486 CUMBERLAND AVENUE

Memorandum from Department of Building Inspection, Portland, Maine

Permit to construct two fire escapes as per plans is being issued herewith subject to the following Building Code requirements:

Construct two (2) fire escapes as per plans.

486 Cumberland Ave.

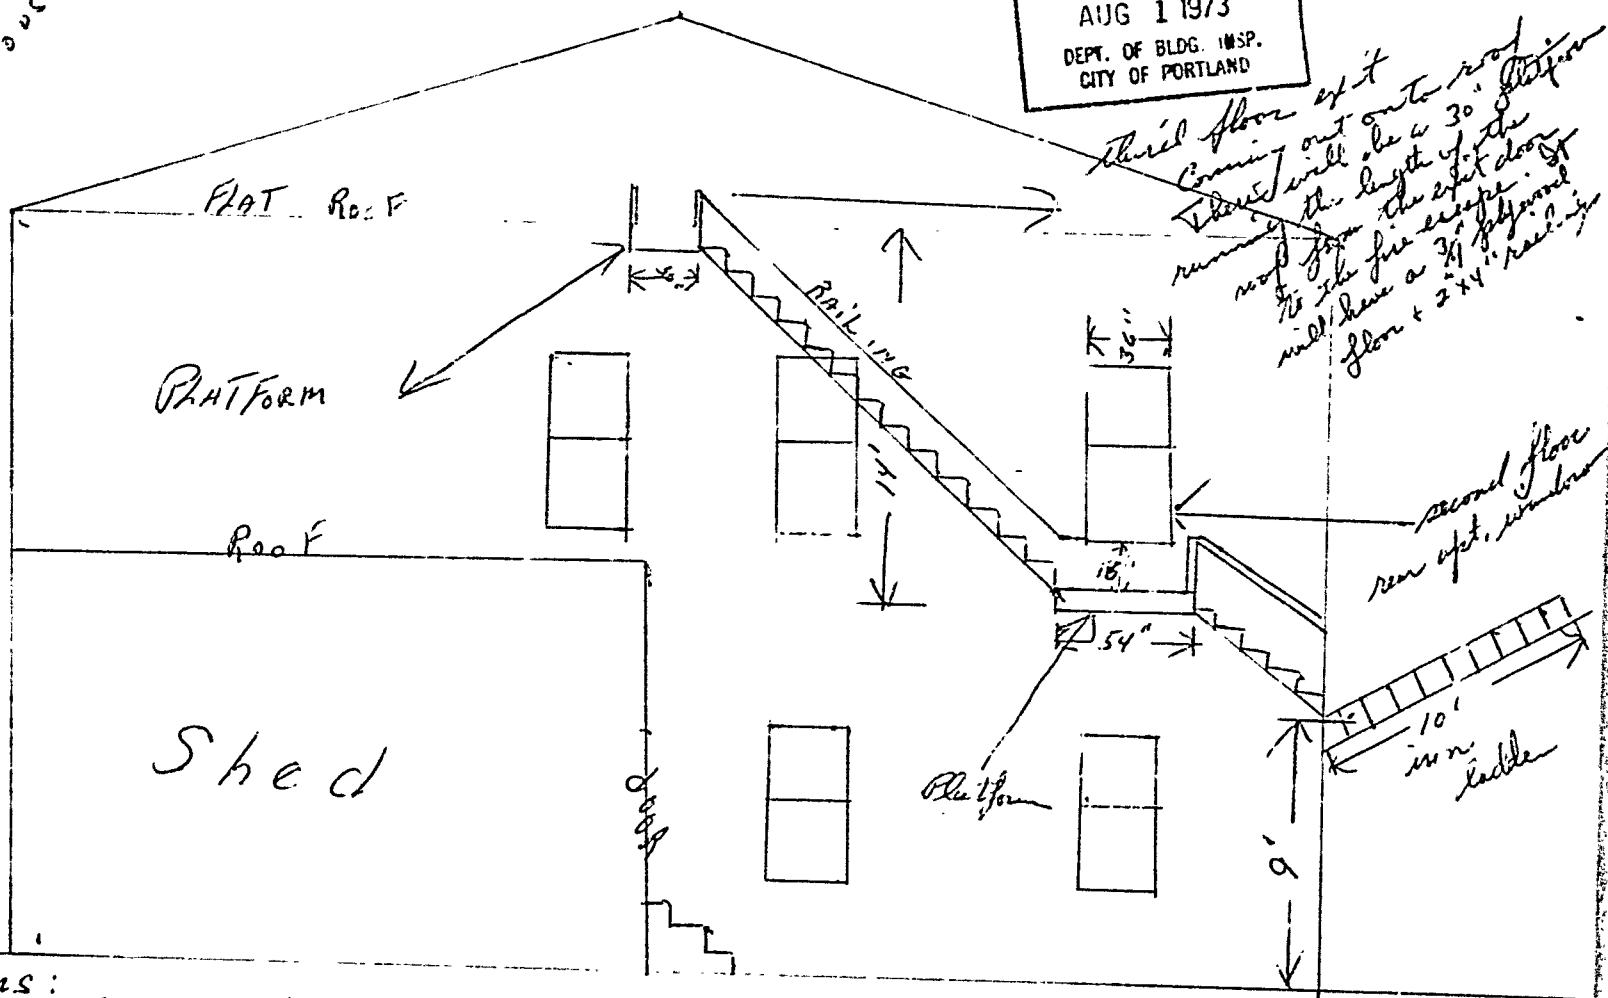
Where double hung windows are being used as means of egress it is necessary that the window when open will have an opening of no less than 28 inches in the clear.

The wooden platform are to be built with 4x6 sills (all one piece in cross section) set with the 6 inch dimension upright. The 2x6 inch members, 16 inches on centers are to be notched over 2x3 nailing strips.

The thru bolts which hold the 4x6 knee braces are to be no less in size than 3/4 of an inch.

486 Cumberland Ave.

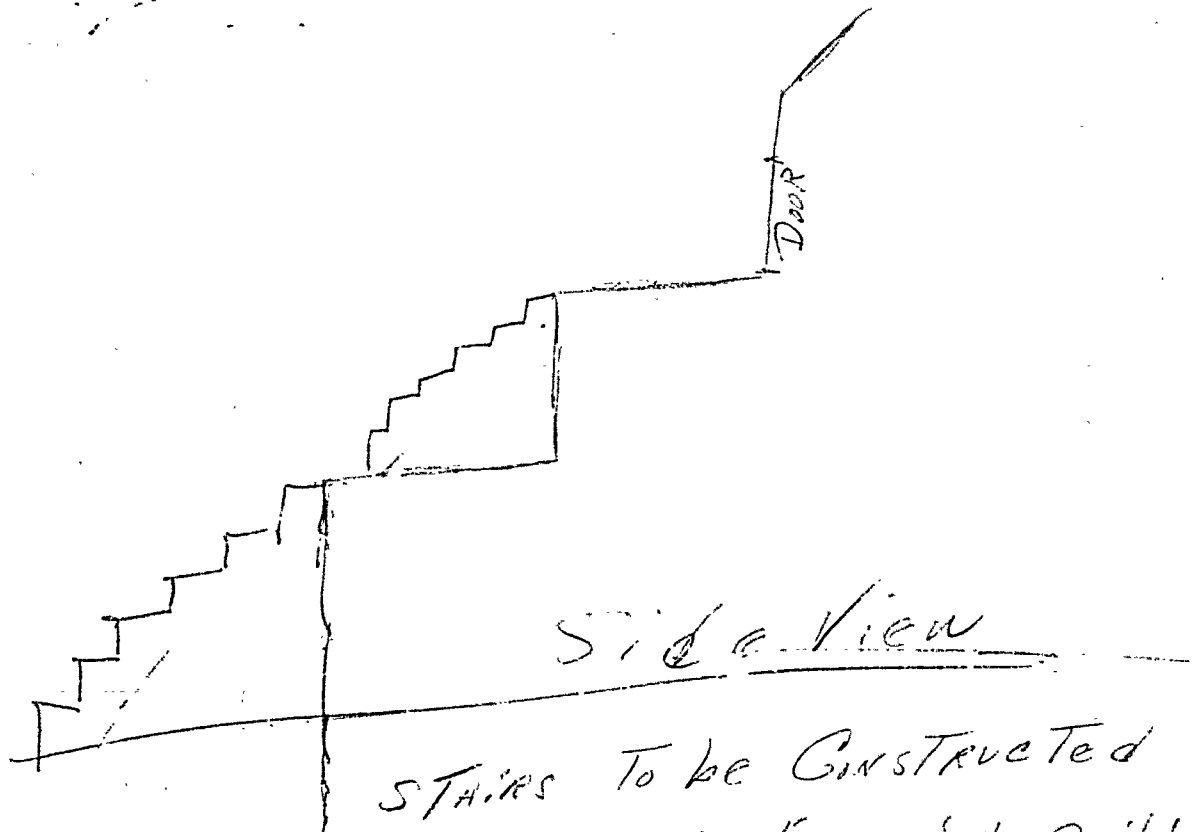
This office is unable to issue a permit to erect a second means of egress from third floor to roof, and from roof to ground as per plan because the Fire Department maintains that the "proposed fire escape will not provide adequate exiting".

SPECIAL COMMENTS: Proposed fire escape will not provide ADAquate egress.
